Staff Report & Recommendation

Design Review Board

SUBJECT: DRB19-0397
5245 North Bay Road

The applicant has submitted plans entitled "Bay Road Residence", as prepared by **Beilinson_Gomez Architects PA**, dated 05/06/2019.

Portion of the 1926 Plat of LaGorce Golf Subdivision (subject property Lot 2 Block 17)

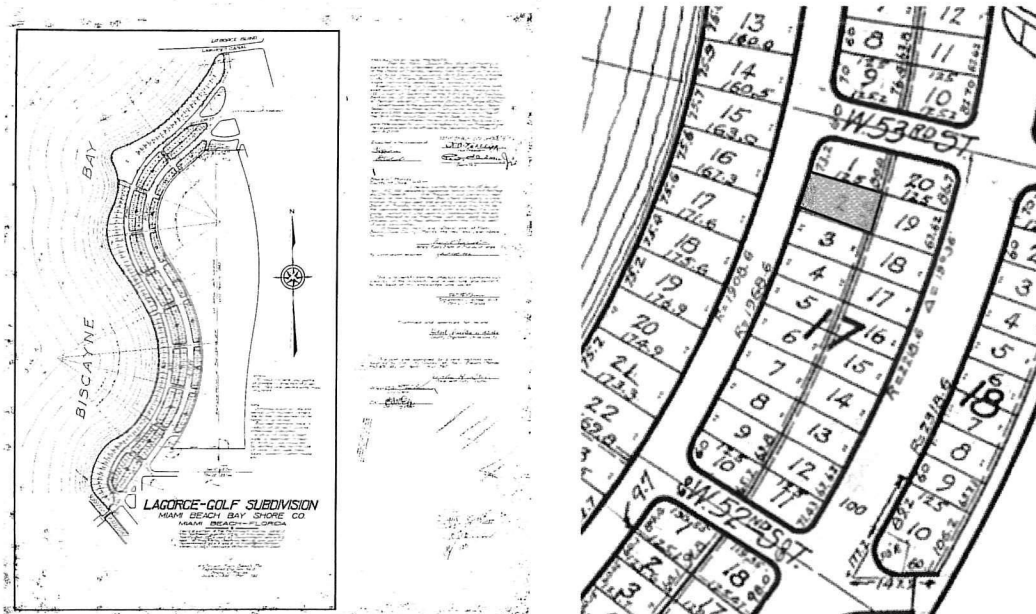
The property is an irregular shaped lot with a curved front property line of 60'-0" and a curved rear property line measuring 63.8'. Based on the parcel's geometry, is considered as 'a lot greater than 60'-0" in width' because the lot width is measured at the required 20'-0" front setback, which in this case results in a lot width larger than 60'-0". Therefore, both interior side yards have a minimum setback requirement of 10'-0". The applicant is proposing setbacks of 7'-6" on both side yards, as if the property were a rectangular lot with 60'-0" in width. Staff would note that the surrounding interior properties along the east side

of North Bay Road and the abutting properties fronting Alton Road also have similar trapezoid shape with approximately 60' at the front and slightly wider toward the rear and located in the RS-4 zoning district. The properties on the opposite side of North Bay Road are subject to the same regulations of 10'-0" minimum side setbacks, yet those are larger; waterfront sites zoned RS-2.

The subject property is an interior lot on a block within the Plat of LaGorce Golf Subdivision, which was historically platted on April 9, 1926 as a series of eighteen serpentine interior blocks and a stretch of Bayfront parcels west of the La Gorce Golf Club and extending from Surprise Waterway to La Gorce Canal.

The recent changes to Section 142-106 pertaining to side setback requirements require that lots with over 60'-0" in width have an increased setback of a minimum of 10'-0" along both side yards. Lots with 60'-0" or less of frontage have a minimum of 7'-6" required side setback.

This would require the subject property, with less than 4" (or 60'-3 13/16") of additional frontage, to offset the building envelope an additional 5'-0" (2'-6" for each side). Staff finds that practical difficulties exist for the variances requested based on the irregular shape on the lot, as originally platted. The granting of these variances should not have an adverse impact on the adjacent properties. For these reasons, staff recommends approval of the variances.
